ARCHITECTURE PLANNING URBAN DESIGN

RE: 147 Arroyo Grande Way

I reviewed the drawings and evaluated the site context. My comments and recommendations are as follows:

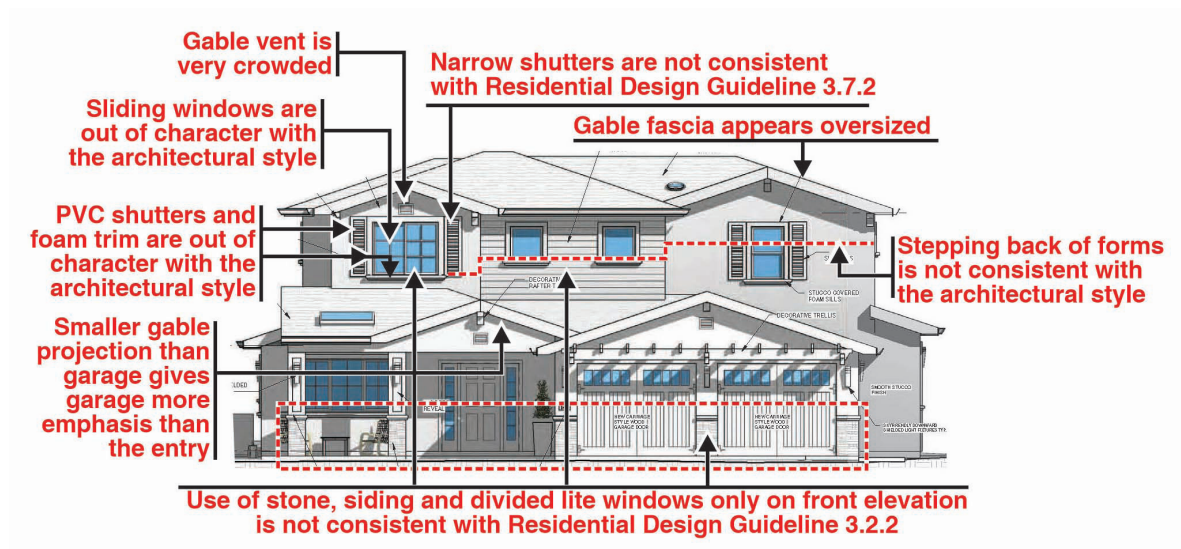
1. The second floor addition is much larger than that of the only other home in the immediate neighborhood with a second story - see streetscape and comparative elevation illustrations below

The proposed height and bulk would not be consistent with Residential Design Guideline 3.3.2.

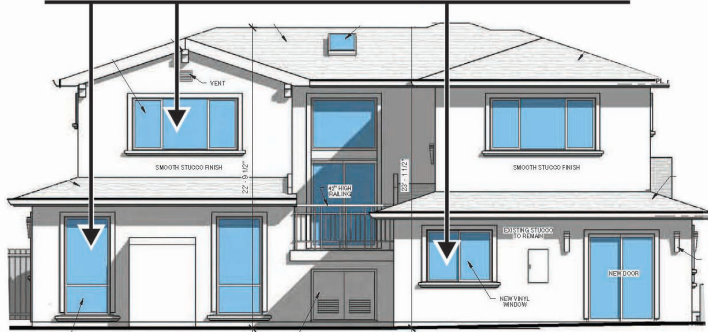
Mix of window types and proportions is not consistent with Residential Design Guideline 3.7.2

- Utilize casement windows rather than the proposed sliding windows.
- Use wood trim on all windows in lieu of the proposed foam trim.
- Should the applicant wish to add divided lites to the windows, they should be either true divided lites or simulated divided lites (see illustration below), and they should be used consistently in all windows.

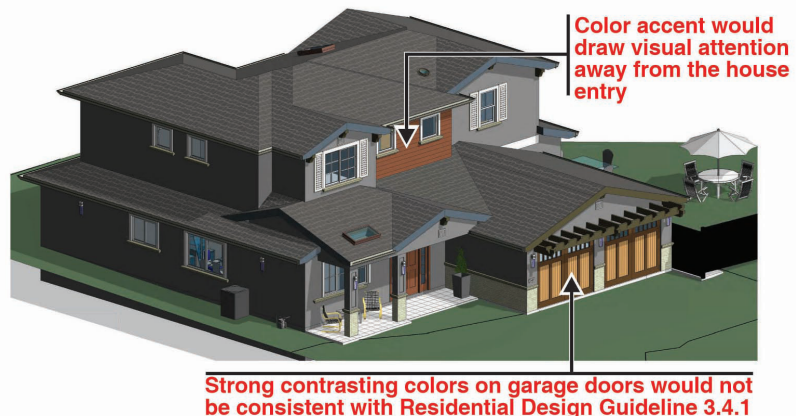
4. The gable fascias appear oversized.
5. The gable end overhang at the entry is smaller than that on the garage which would give more visual prominence to the garage which would not be consistent with Residential Design Guideline 3.4.1.

- Avoid designs that allow the garage to dominate the street facade.
 - Limit the garage width to a maximum of 50 percent of the total facade width.
6. The strong contrasting colors on the garage doors and the color accent on the upper front facade wall would also draw visual attention to the garage and away from the entry.

APPROACH #1: EXPAND FLOOR AREA TO IMPROVE DESIGN

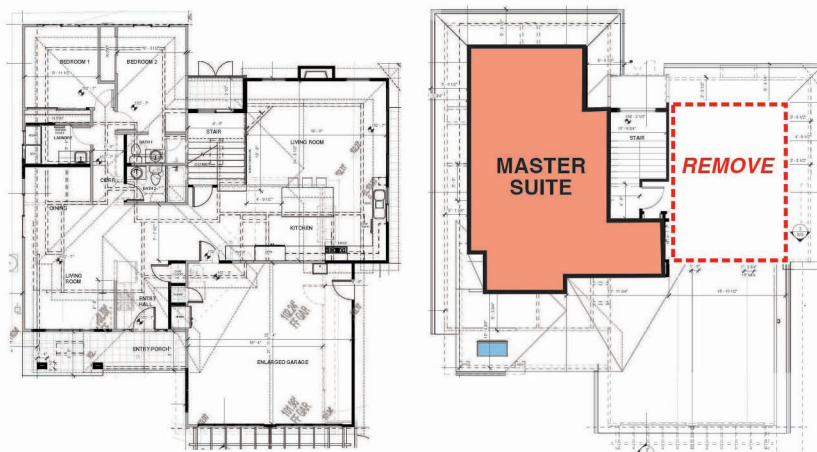
In the studies that I conducted, I could not find a reasonable way to retain the proposed plan floor area while mitigating the issue of second floor height and bulk relative to other homes in the immediate neighborhood. The first approach retains the extent of the floor area and plan layouts proposed by the applicant while improving it to be consistent with the Town's Residential Design Guidelines. It does add a small additional floor area on the second floor to bring the design into better conformance to the proposed architectural style.

This approach would set a benchmark against which other approaches to reducing second floor bulk can be compared.

APPROACH #2: RELOCATE MASTER SUITE | REMOVE MASS

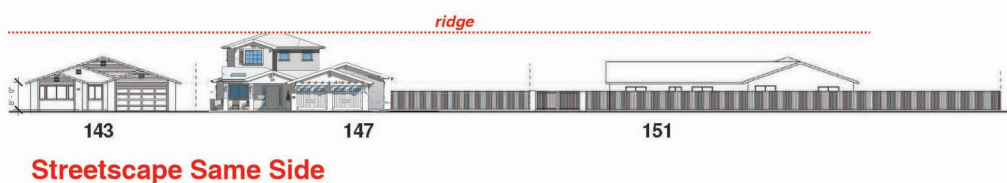
Approaches #2 and #3 both remove the floor area currently proposed as the location of the second floor Master Bedroom Suite. This would require the elimination of two of the four proposed smaller bedrooms.

- Relocation of the Master Bedroom Suite to the second floor area currently proposed for Bedrooms 3 and 4. That area which is somewhat larger than the currently proposed Master Bedroom Suite might allow the addition of a second floor Laundry Room and other bonus rooms or areas.

Remove grids
or use true
or simulated
divided lites on
all windows

Remove
shutters

Remove stone base or continue around all sides of house

APPROACH #3: RELOCATE MASTER SUITE | REMOVE MASS

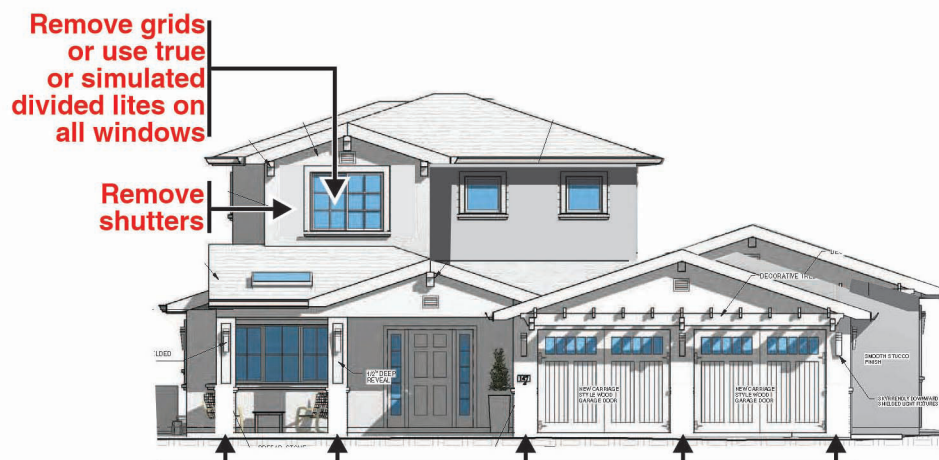
- Relocation of the Master Bedroom Suite to the first floor area currently proposed for Bedrooms 1 and 2. The available floor area would be larger than currently proposed, and would likely allow a more spacious Master Bath which, in its current proposed layout, is rather small for a Master Bath.

Remove stone base or continue around all sides of house

APPROACH #4: RELOCATE MASTER SUITE | REDUCE MASS

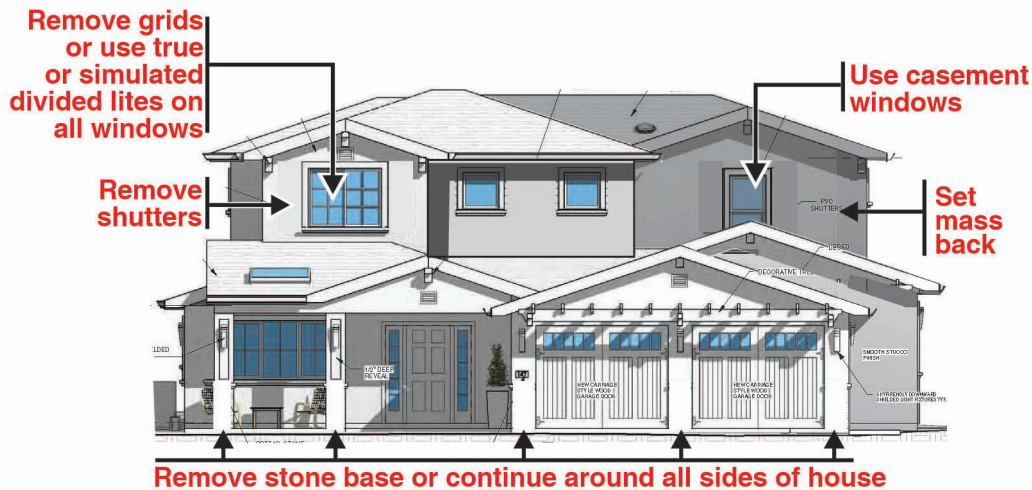
Approach #4 would provide some mitigation to the visual bulk of the currently proposed second floor addition by eliminating one of the proposed smaller bedrooms, and moving some of the second floor mass away from the front facade. This would provide some small level of mitigation.

- Relocation of the Master Bedroom Suite to the first floor area currently proposed for Bedrooms 1 and 2.
- Relocation of one of the currently proposed smaller bedrooms to the second floor area currently proposed for the Master Bedroom Suite. This would result in a Master Bedroom Suite on the first floor and three smaller bedrooms on the second. The smaller second floor bedroom would not be very efficient given its awkward layout of spaces, but that was a condition that would exist for the proposed Master Bedroom Suite.
